**NEW YORK STATE THRUWAY AUTHORITY
DEPARTMENT OF ENGINEERING**

**ALBANY, NY
FEBRUARY 8, 2024**

**AMENDMENT NO. 1
TO**

**CONTRACT TANY 24-8
D214964
2" MILL AND INLAY, SAFETY
IMPROVEMENTS AND MISCELLANEOUS WORK
BETWEEN MILEPOST 47.6+/- AND MILEPOST 60.1+/-
IN THE NEW YORK DIVISION
OF THE NEW YORK STATE THRUWAY
IN ORANGE COUNTY**

DRAWING NUMBER:
GP-13

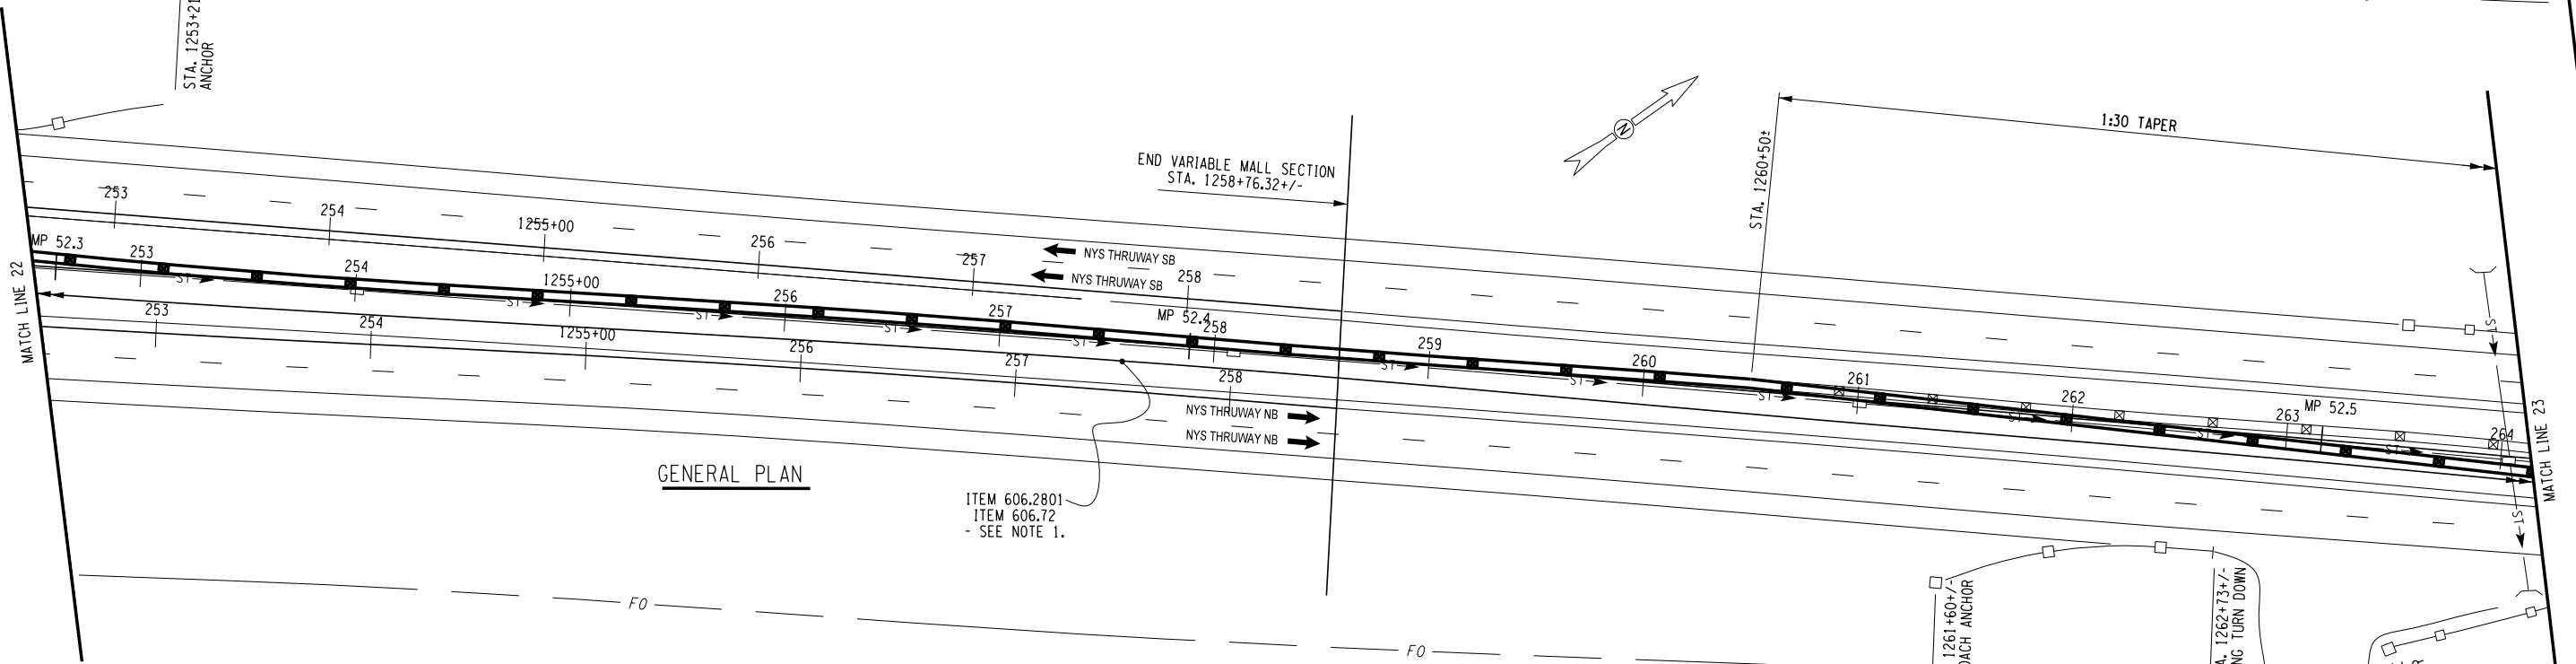
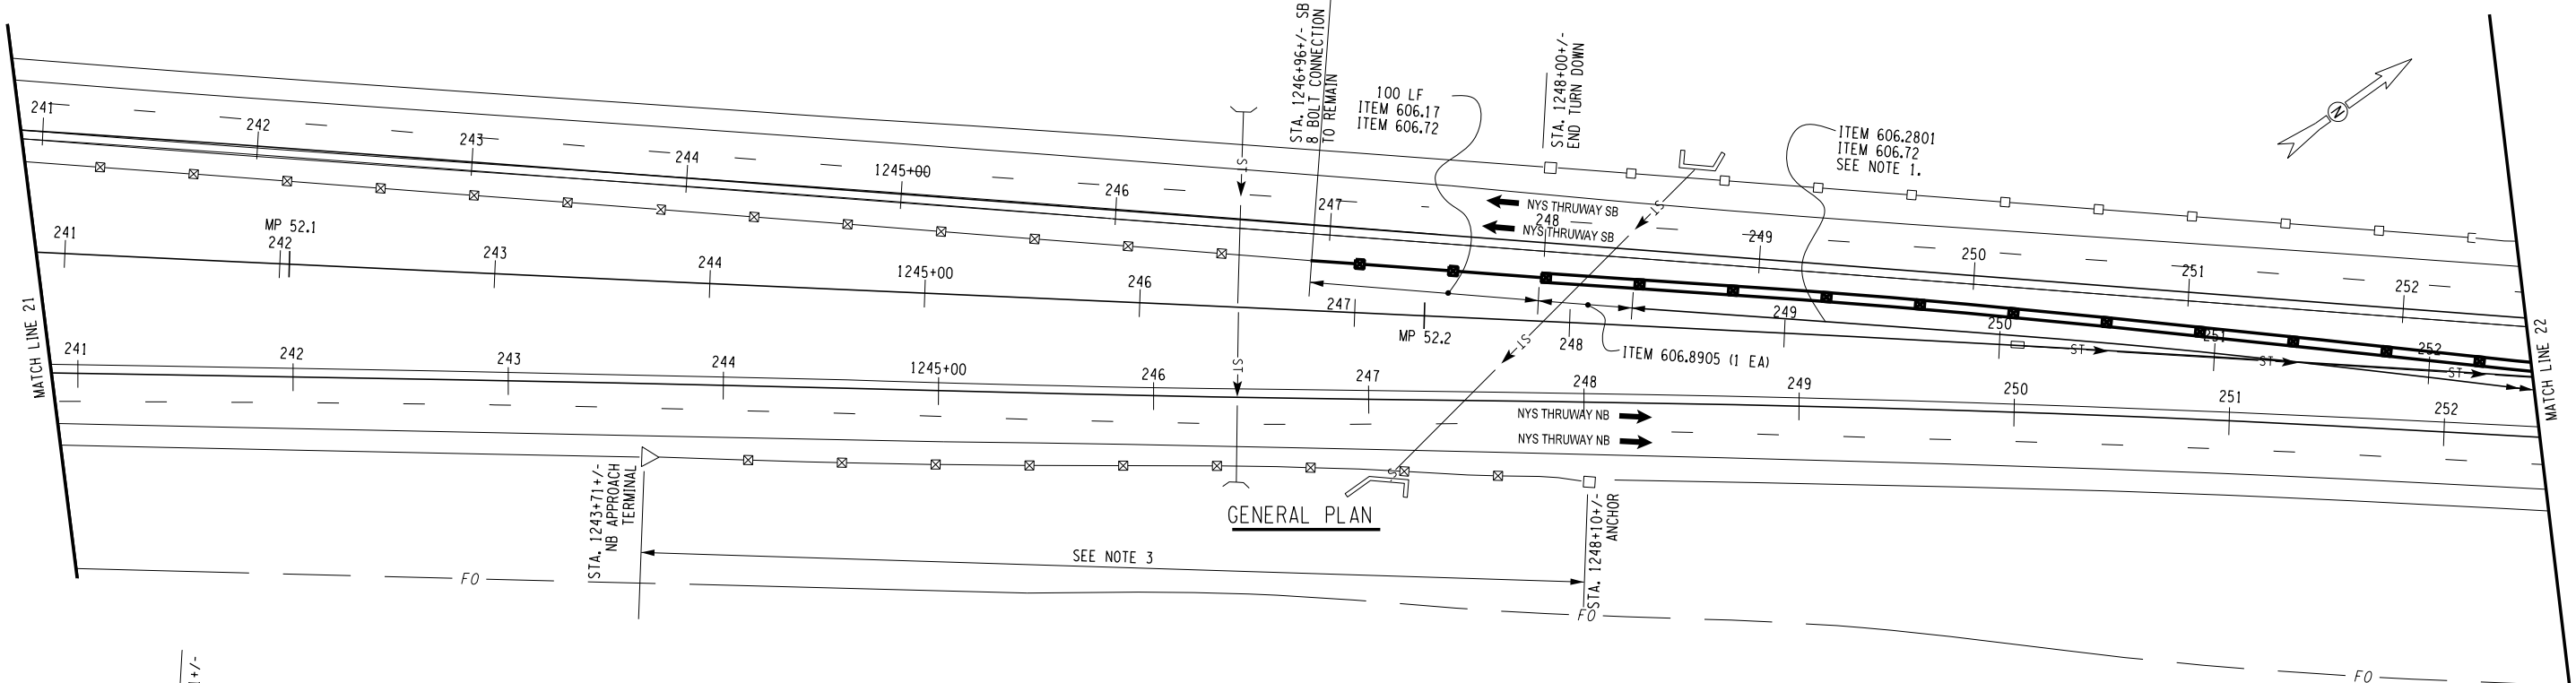
18. **DELETE** Drawing Number GP-13, Sheet 84 of 108, and **SUBSTITUTE** with the attached Drawing Number GP-13, Sheet 84-A1 of 108. Reference to (new) Item 606.58 and a new Note 3. have been added.

1. INSTALL 606.2801 IN THE SAME LOCATION AS THE EXISTING MEDIAN BARRIER UP TO STA. 1260+50.
2. REFER TO STANDARD SHEET 606-27 FOR TRANSITION TO NEW HPBO (MOD.) CBMB.
3. FOR APPROXIMATELY 400' ABOUT HALF OF THE BLOCK-OUTS ARE TWISTED OUT OF ALIGNMENT AND ARE TO BE REPLACED A.O.B.E. COSTS TO BE PAID FOR UNDER ITEM 606.58.

DRAWING NUMBER:
GP-14

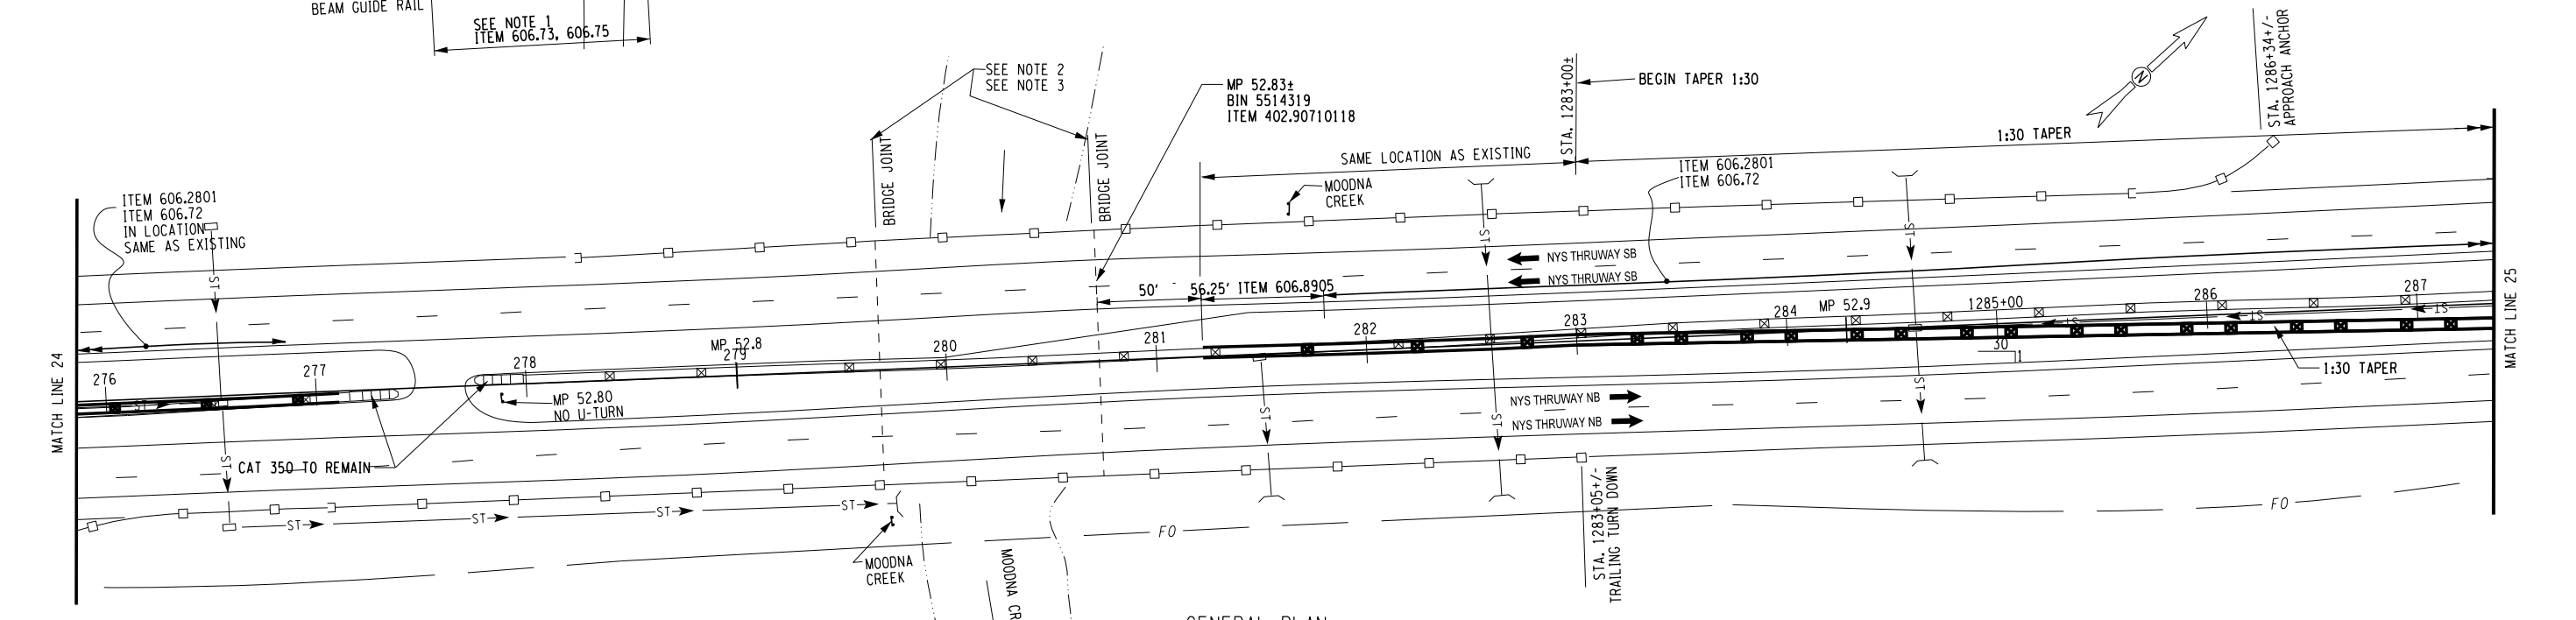
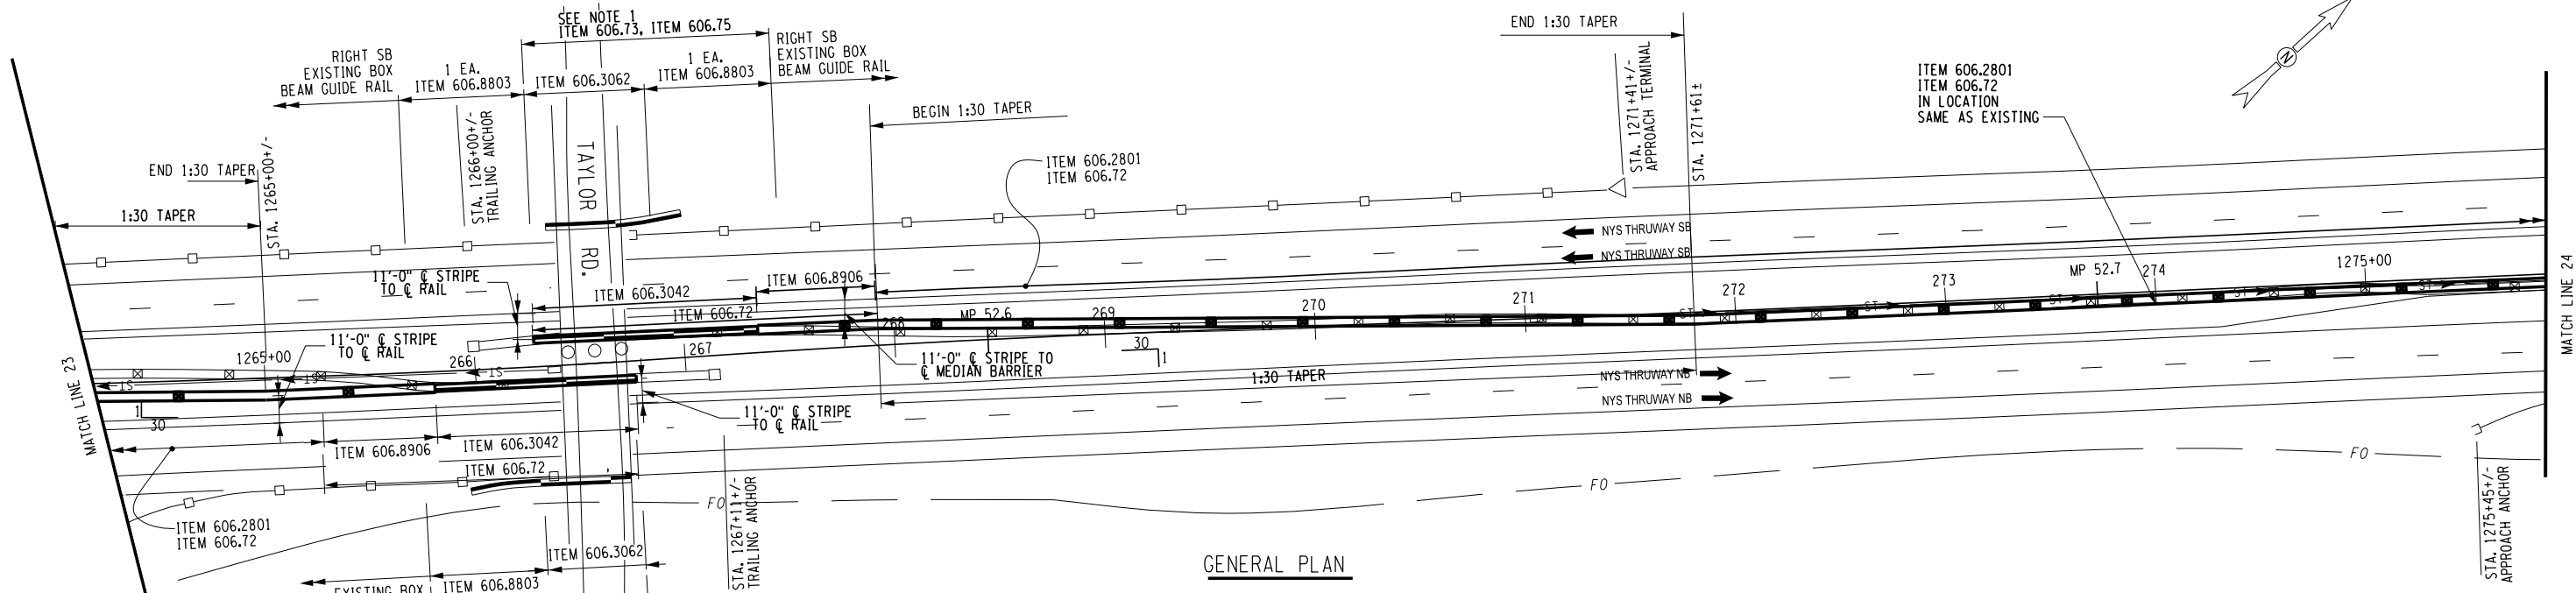
19. **DELETE** Drawing Number GP-14, Sheet 85 of 108, and **SUBSTITUTE** with the attached Drawing Number GP-14, Sheet 85-A1 of 108. Deleted the redundant barrier lengths previously shown for the Taylor Road Bridge.

TITLE OF PROJECT PAVEMENT RESURFACING AND SAFETY IMPROVEMENT	CONTRACT NUMBER: TANY 24-8
LOCATION OF PROJECT NY DIVISION MP 48.0 TO 60.1	DATE: 1/2024
TITLE OF DRAWING GENERAL PLAN	DRAWING NUMBER: GP-15

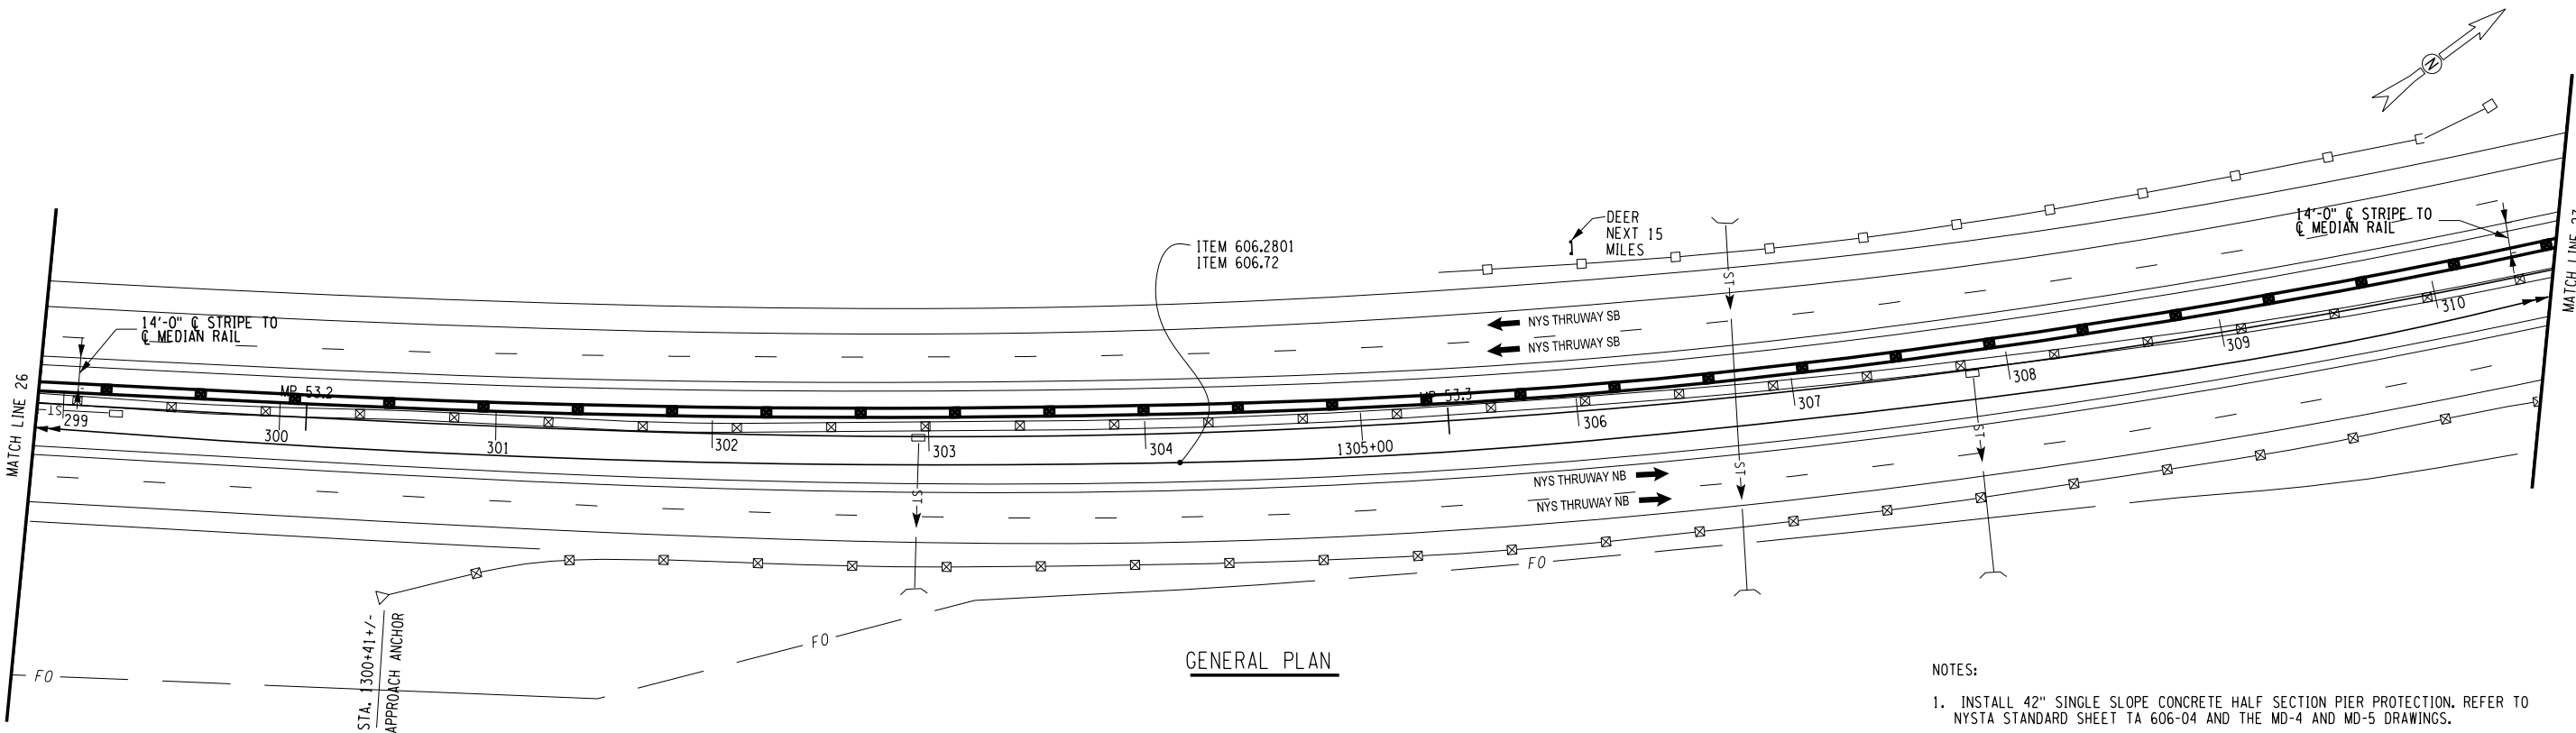
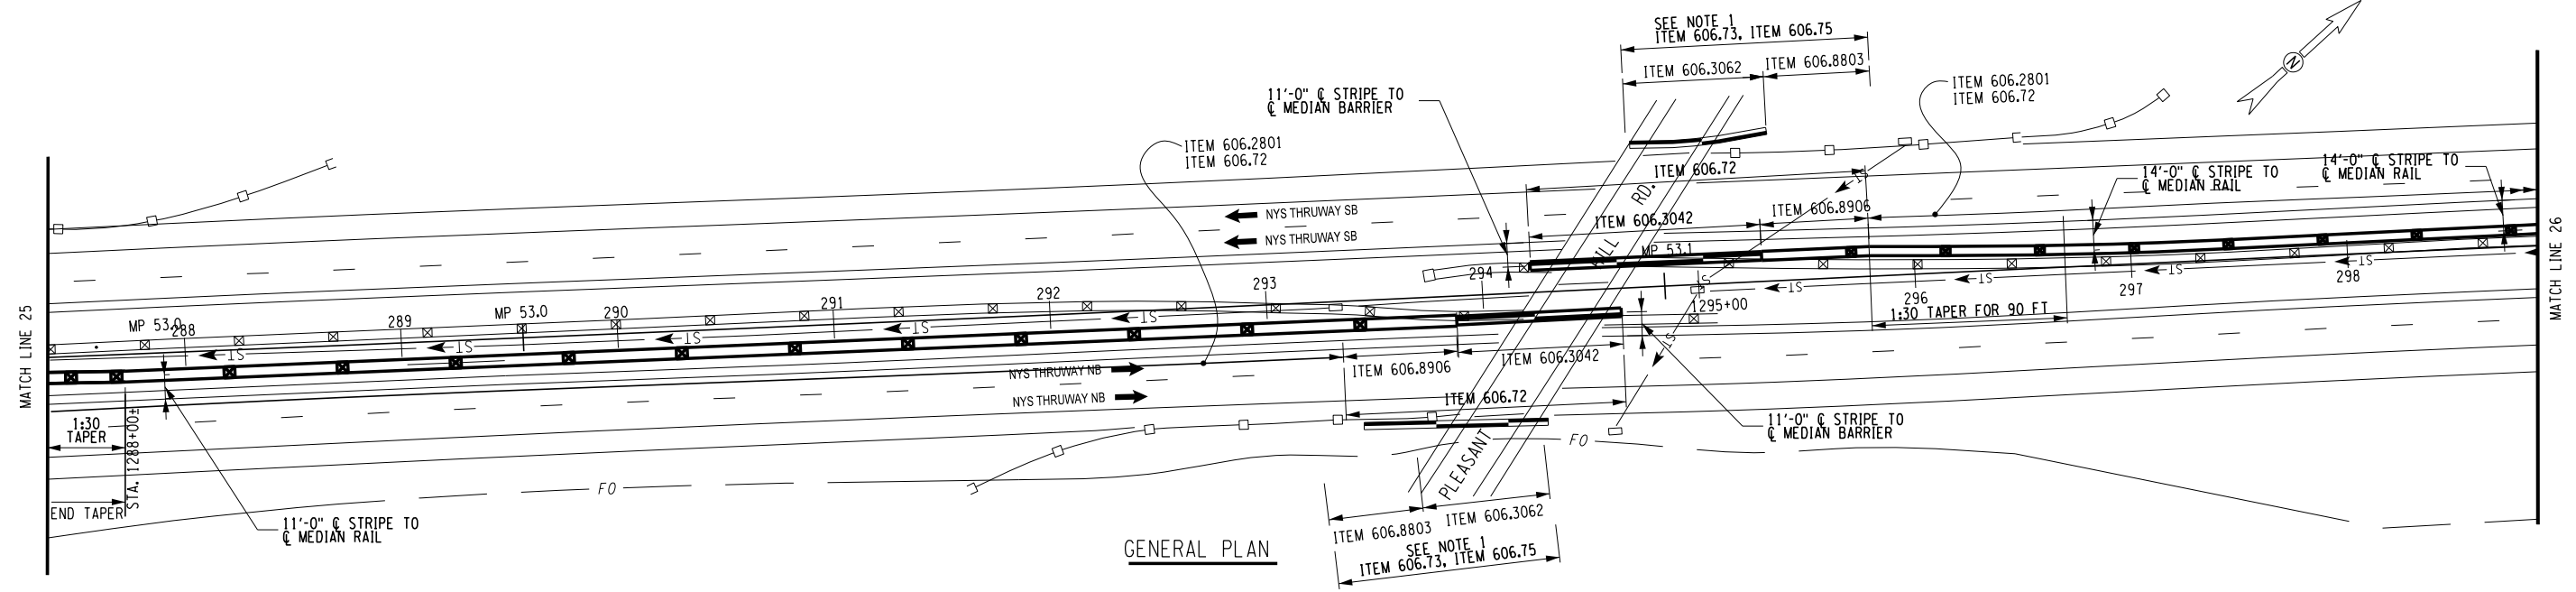
20. **DELETE** Drawing Number GP-15, Sheet 86 of 108, and **SUBSTITUTE** with the attached Drawing Number GP-15, Sheet 86-A1 of 108. Deleted the redundant barrier lengths previously shown for the Pleasant Hill Road Bridge.
